MIL-S-19500/331A(EL)
AMENDMENT-2

29 January 1974
SUPERSEDING
AMEND-1
15 June 1971

SEMICONDUCTOR DEVICE, TRANSISTOR, PNP, GERMANIUM
TYPES 2N1553A through 2N1556A

FIGURE 3 Safe operating Area curves.

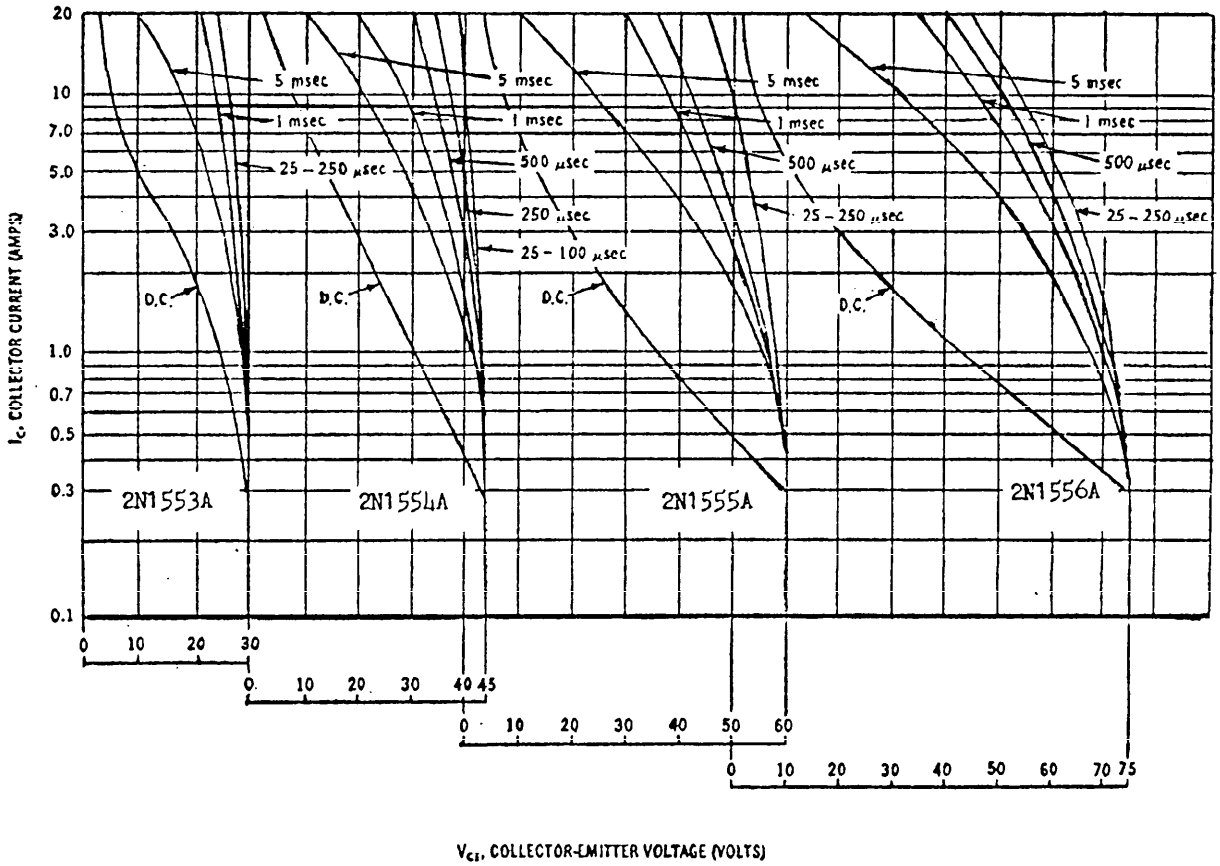
Figure 3: Remove and substitute the attached Figure 3.

Figure 4. Safe area Test circuit

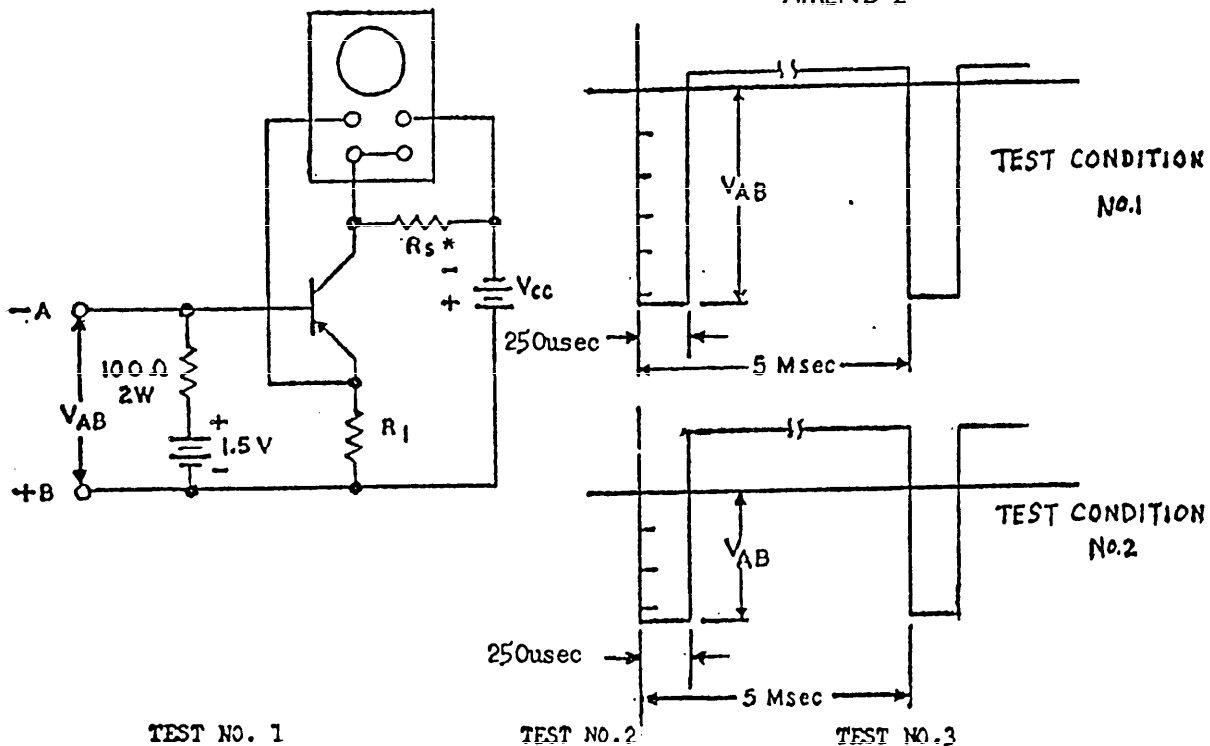
Figure 4: Remove and substitute the attached Figure 4.
